SAHRA Gunstfontein WEF Site Visit Report: 9-10 June 2016

Ms. Natasha Higgitt
nhiggitt@sahra.org.za
SAHRIS Case ID: 8383

Figure 1: Track log of site visit and points assessed

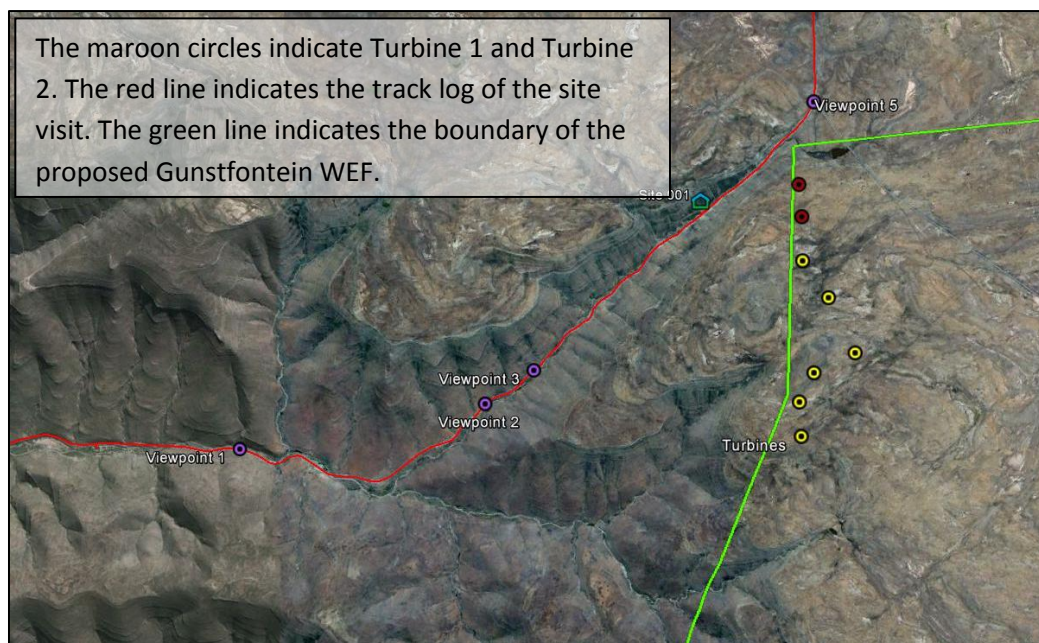
A site visit was conducted on the 9-10 June 2016 by Natasha Higgitt (Heritage Case officer) and Ragna Redelstorff (SAHRA Heritage Officer Palaeontology). A total of four points along the Verlatenkloof Pass were visited. These points were the result of the identification of visual impact zones as indicated in the response by Savannah on 6 April (See Appendix B). Photomontages were supplied by the Visual Impact Specialist and were compared to on-site conditions. The track log and points assessed are depicted in Figure 1 below.

Figure 13: 1901 British Map of the Verlatenkloof Pass

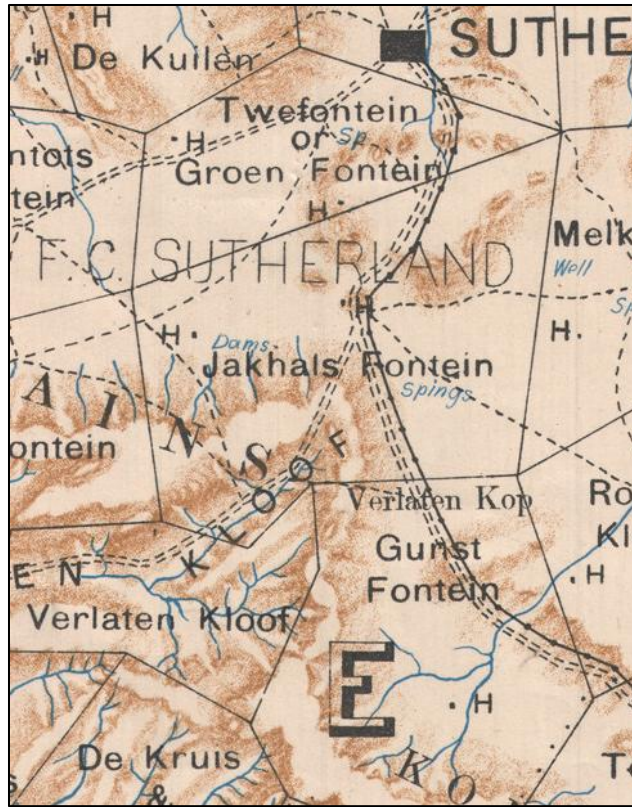
similar age to the pass itself and may have been a toll house to collect money from travelers making use of the pass. According to a 1901 British War map (Figure 13 below) no structures were identified along the pass indicating that the structure may have either not yet been constructed, or it may not have been considered relevant and was therefore not featured on the map.
